ECR status

Linac4 connection

PSB Upgrade
LIIU Project

Partial Disassembly of Linac2

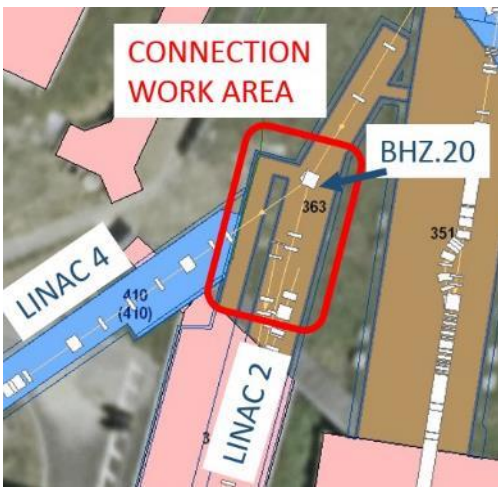
This document concerns the disassembly of Linac2 transfer line from the end of the DTL cavities, DTL cavities not included, up to the LT.BHZ20 magnet to allow the connection of Linac4 to PSB transfer line.

Connection of the Linac4 to the LT.BHZ20

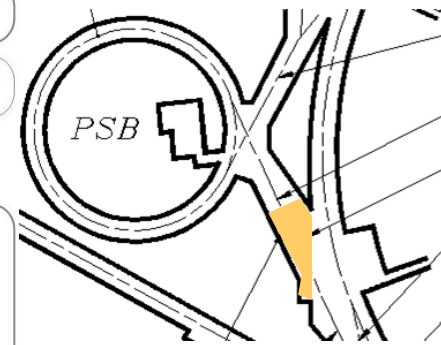
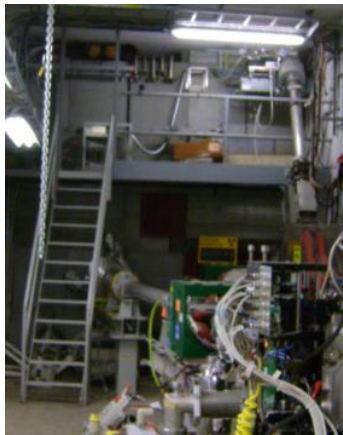
This document concerns the Linac4 connection with the PSB injection transfer line, LT, through the LT.BHZ20 magnet. Prior to start the activities detailed here the partial disassembly of Linac2 described on the ECR CPS-LJ-EC-0003 has to be made leaving the working area free to access to 363/R-402 and install new items like the chicanes.
